## Addendum No. 2

Reference: Mechanical/Electrical/Plumbing Upgrades – Miller Administration Building  
Weber State University – Ogden, Utah  
DFCM Project No. 14031810

## ADDENDUM #2

Project: Weber State University  
Miller Administration M.E.P. Upgrades  
3848 Harrison Boulevard  
Ogden, Utah 84401

**AD101**

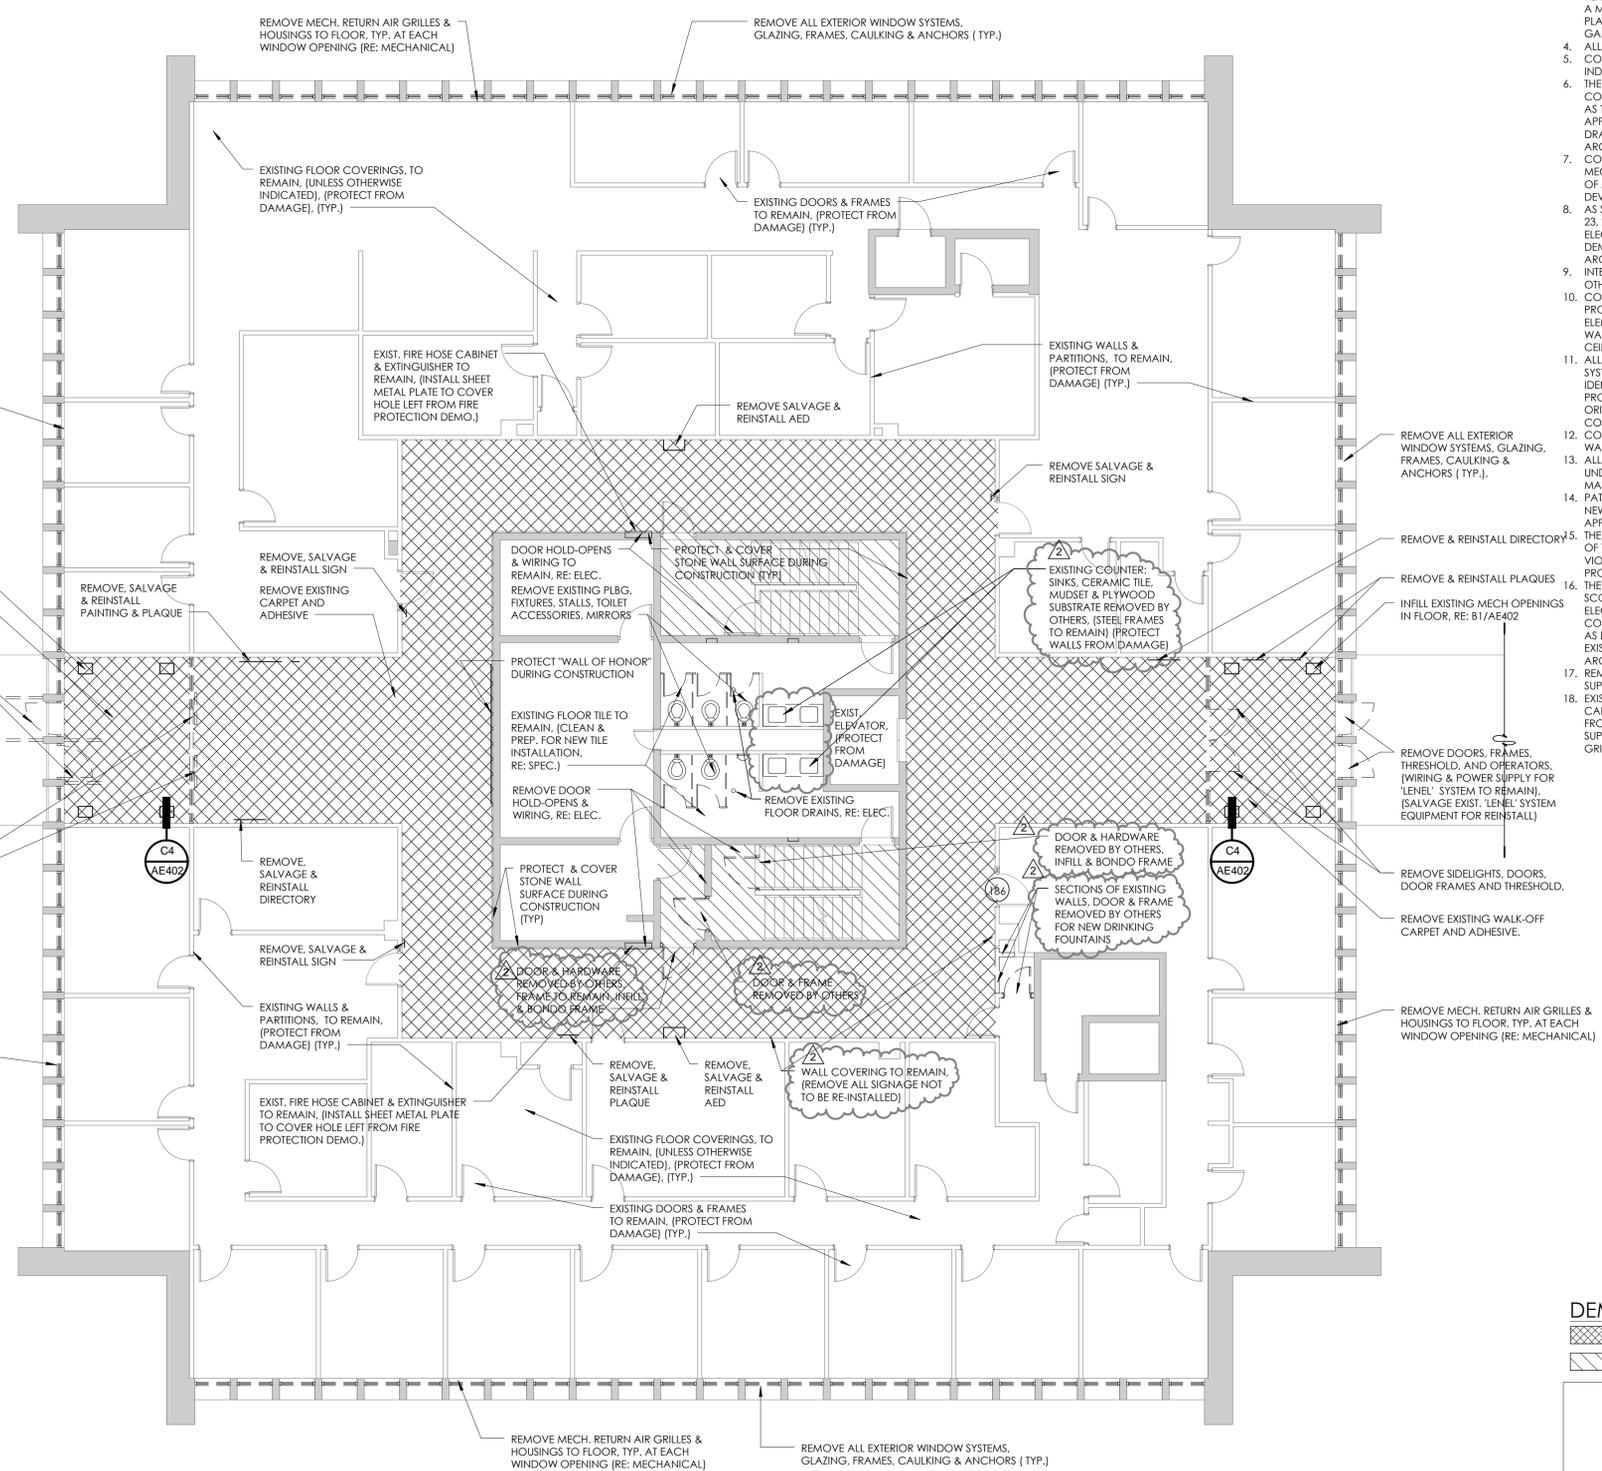
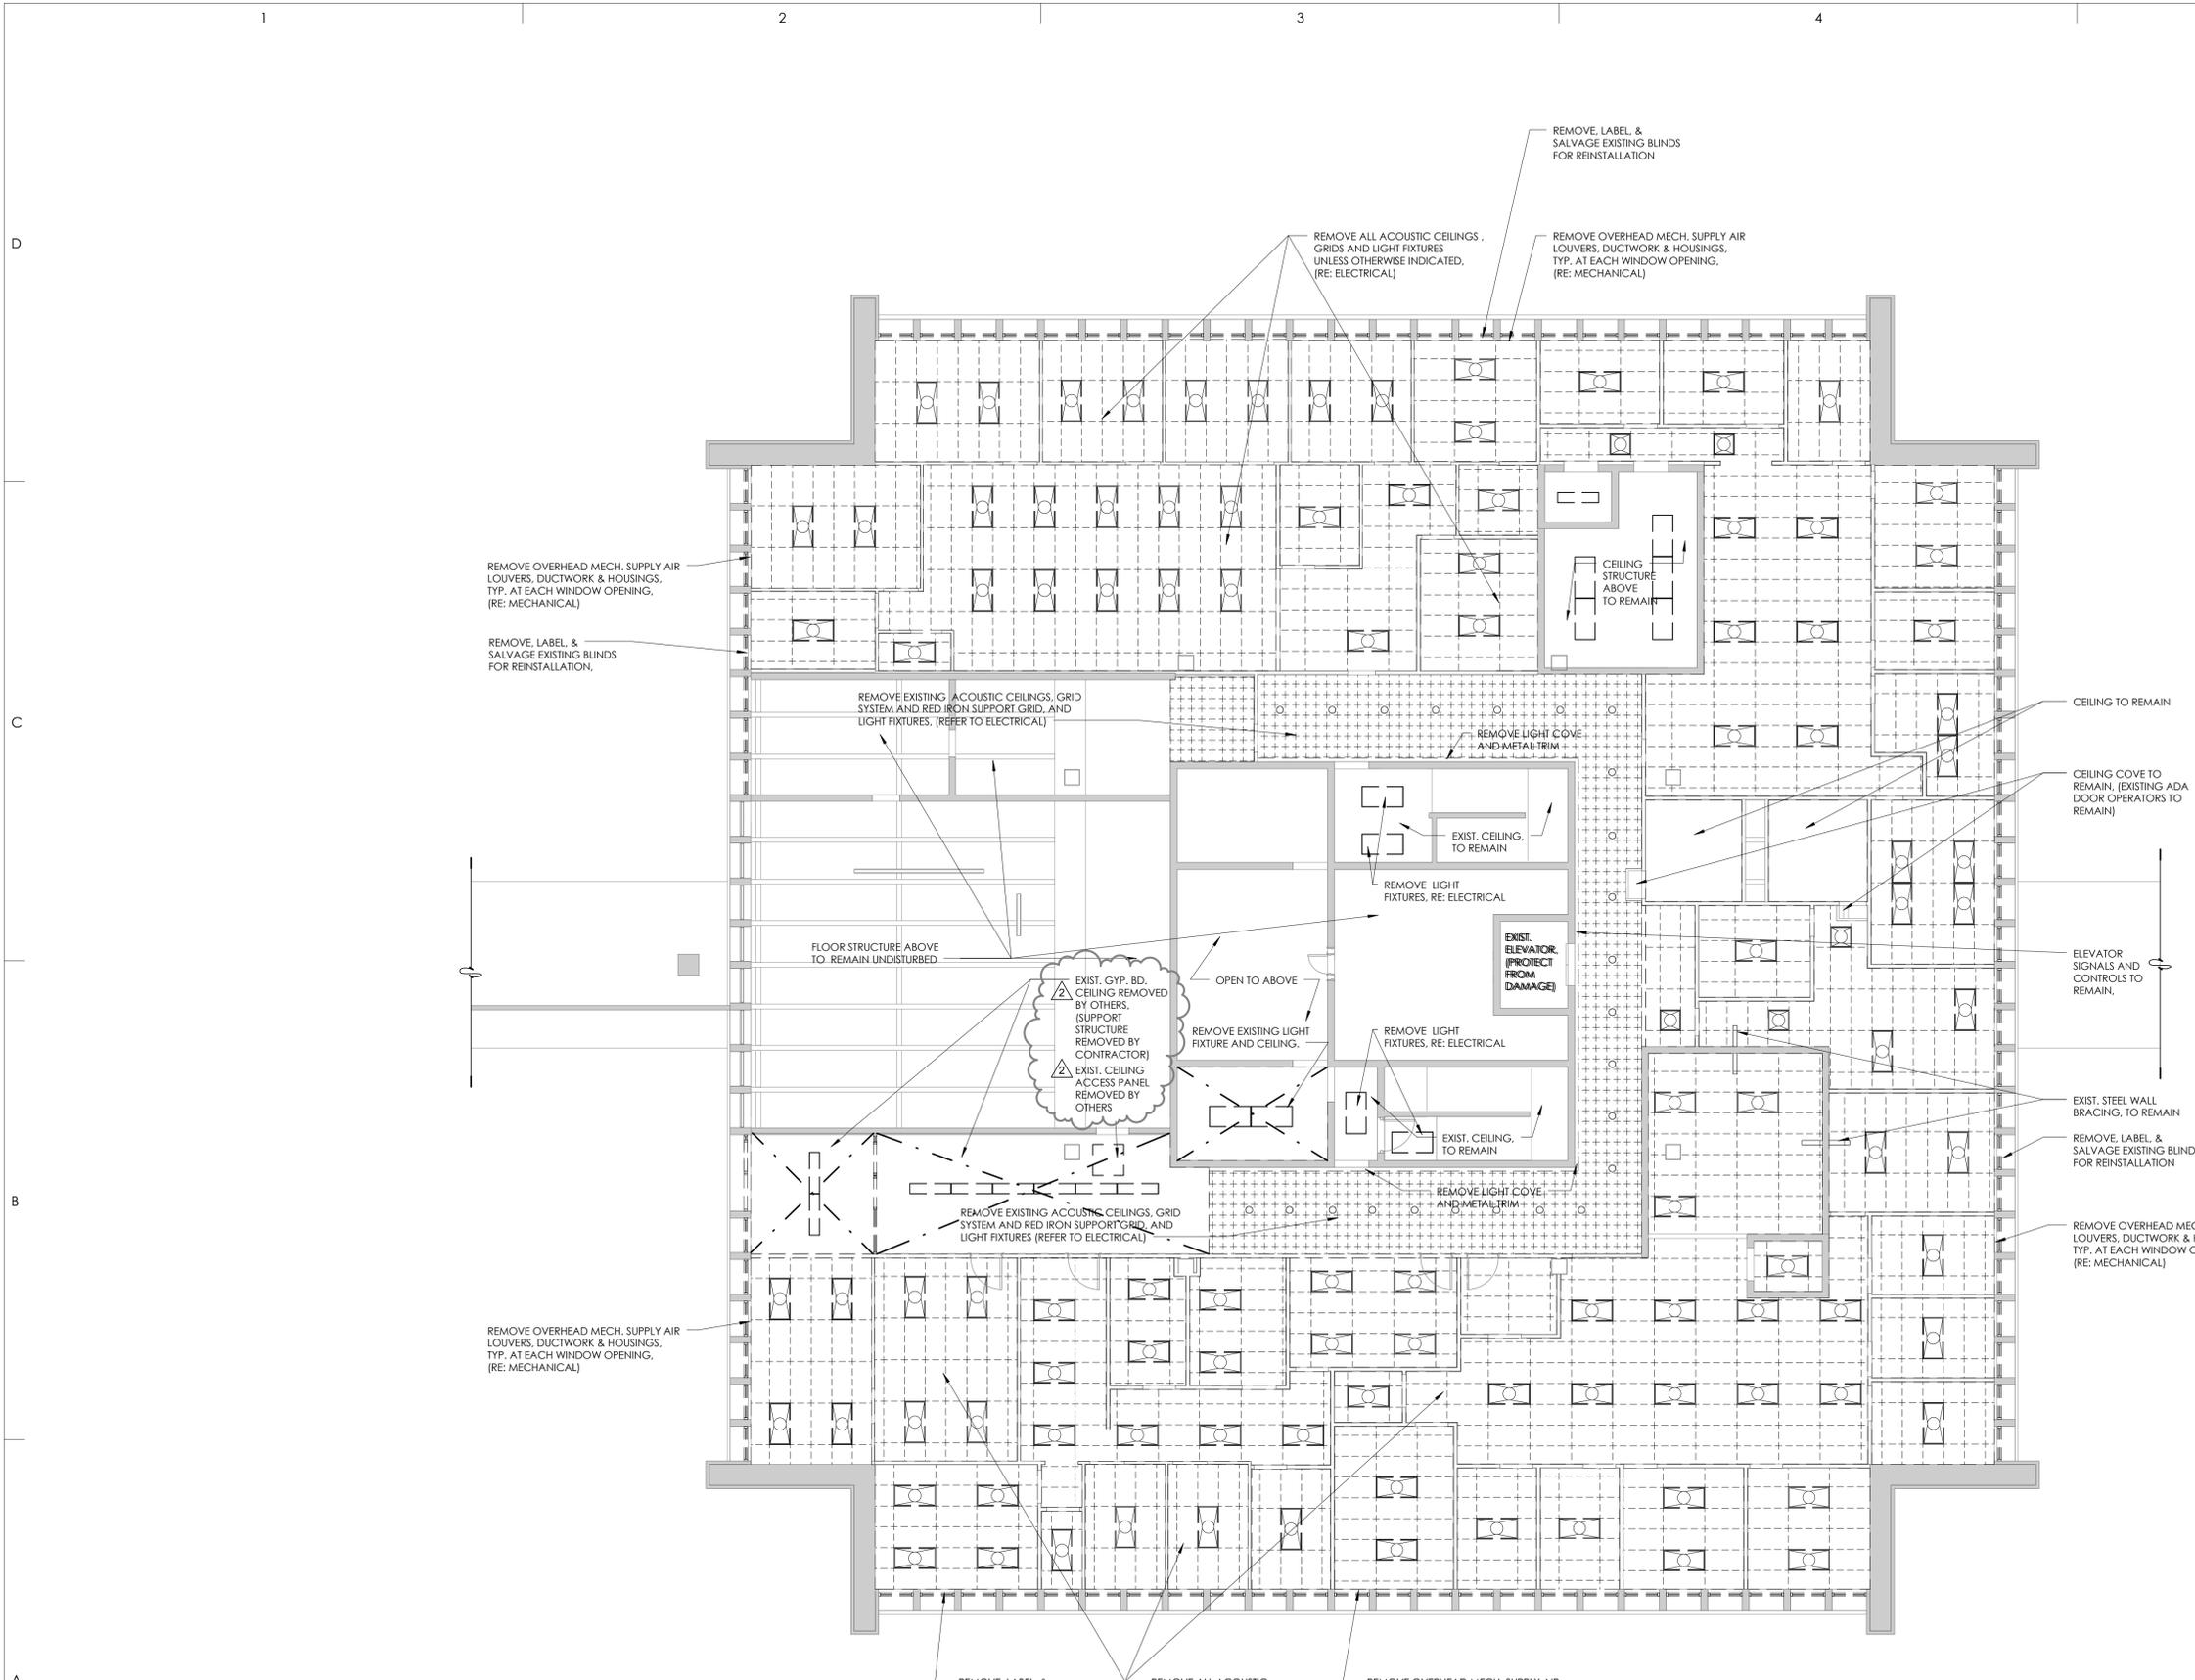
The existing corridor doors on level one and level two that go into the west stair corridors and level two interior stair doorway will be removed by Environmental Abatement, Inc.. The door frames will be ground and prepped by Environmental Abatement, Inc. for frame hardware infills. **(Refer to attached drawing AD100 and AD101).**

The existing west stair doors and frames on level one and level two will be removed by Environmental Abatement, Inc.. **(Refer to attached drawing AD100 and AD101).**

The existing toilet room counters, four total, will be removed by Environmental Abatement, Inc.. This includes the counter ceramic tile, mud set, sink and plywood substrate removal. The existing steel counter frame is to remain for reuse. **(Refer to attached drawing AD101 and AD102).**
